## STAFF REPORT

**Case Number:** 2022-UV3-022  
**Address:** 830 River Road (Approximate address)  
**Location:** Center Township, Council District # 16  
**Petitioner:** Two Chicks & A Hammer 830 LLC, by Austin Aynes  
**Request** Variance of use and development standards of the Consolidated Zoning and Subdivision Ordinance to provide for construction of a three-story duplex (maximum height of 2.5-stories permitted) on a 40-foot wide, 6,000-square foot lot (60-foot lot width, minimum area of 7,200 square feet required), with an open space of 48% (60% required), with a third and fourth dwelling within a detached garage (not permitted), with mechanical equipment, walking paths and patios encroaching within the side yard setbacks (five-foot setback required, walking paths must be two feet from side lot lines).

#### **ADDENDUM FOR MARCH 14, 2023, BOARD OF ZONING APPEALS, DIVISION TWO**

Site plan

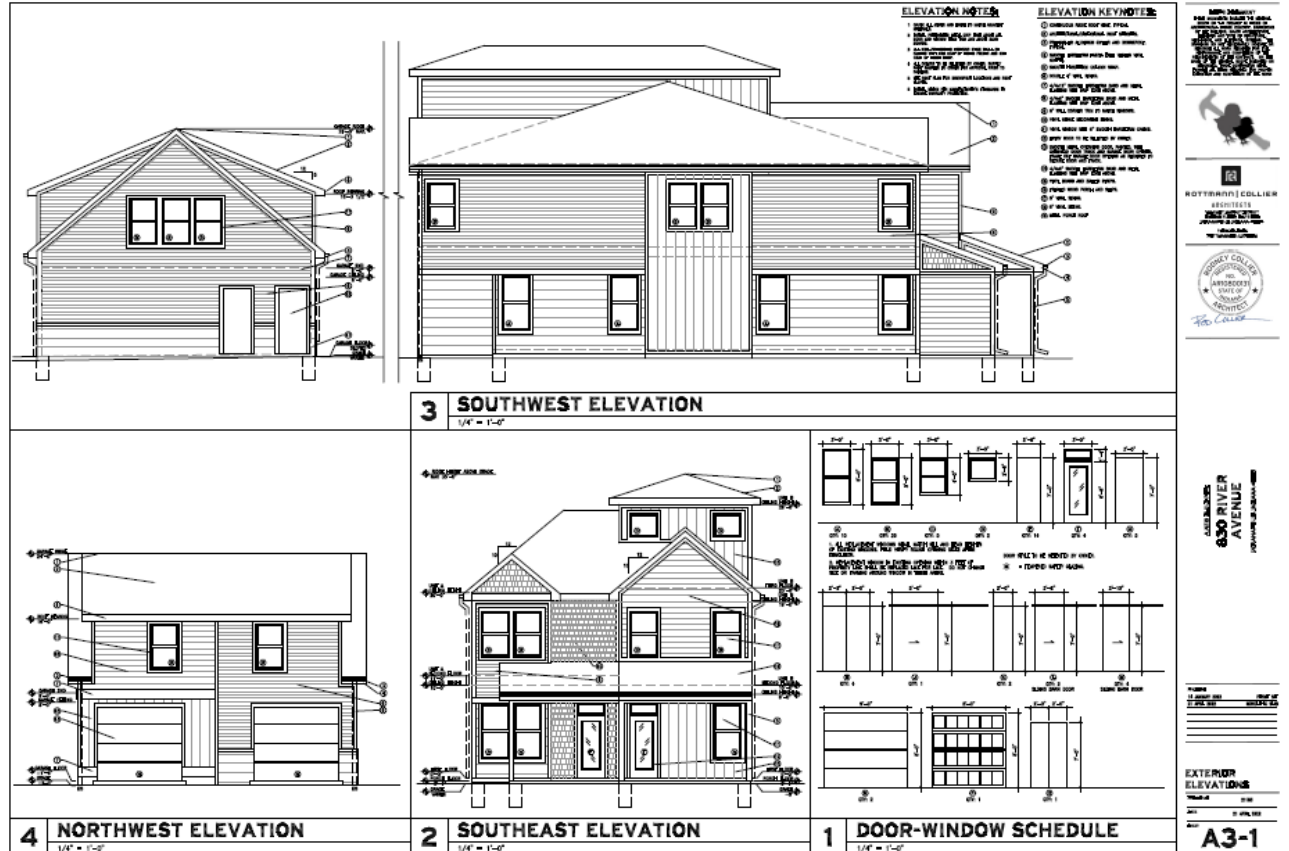
- ◇ The proposed site plan indicates that the main structure would have individual entries to each of the two units, with backyard areas for each of these units. The accessory structure would include two dwelling units that may or may not have visibility to the street or alley. If this petition would be approved, the secondary dwelling unit entries must be visible to the street or alley, for safety purposes.
- ◇ Patios, walking paths and mechanical equipment would encroach into the required side yard setbacks. In the rear, a concrete drive would access the vehicle entries into the garage, from the alley.
